Product Change Notification (PCN)

PCN #: 7M-2024

Date: July 10th, 2024

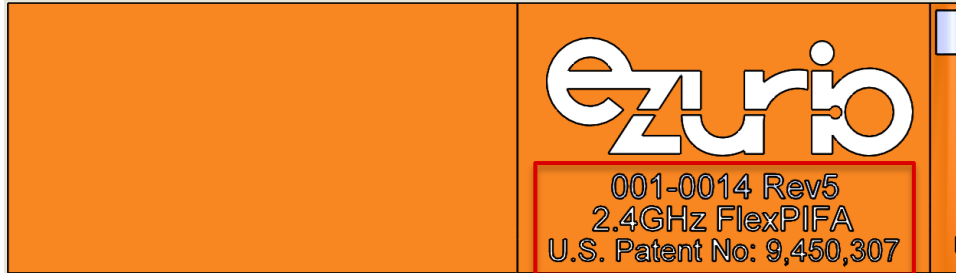
- The company name has been officially changed from Laird Connectivity to Ezurio. As a result, all product PCB Silkscreen labeling and packaging that previously displayed the Laird Connectivity logo will now feature the updated Ezurio logo. This change includes, but is not limited to:
 - Product labels
 - Product packaging

- This change is being implemented because the company name has been officially changed from Laird Connectivity to Ezurio.

5.2 Bag Label

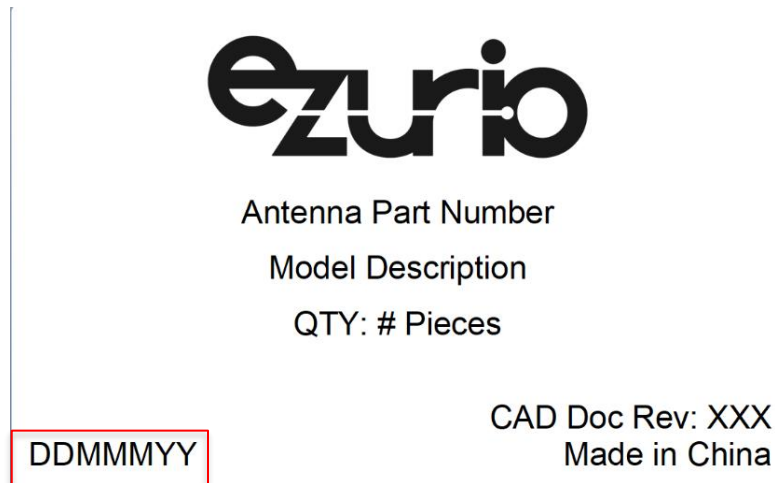
- Manufacturing date on the bag label will be July 2024 or later
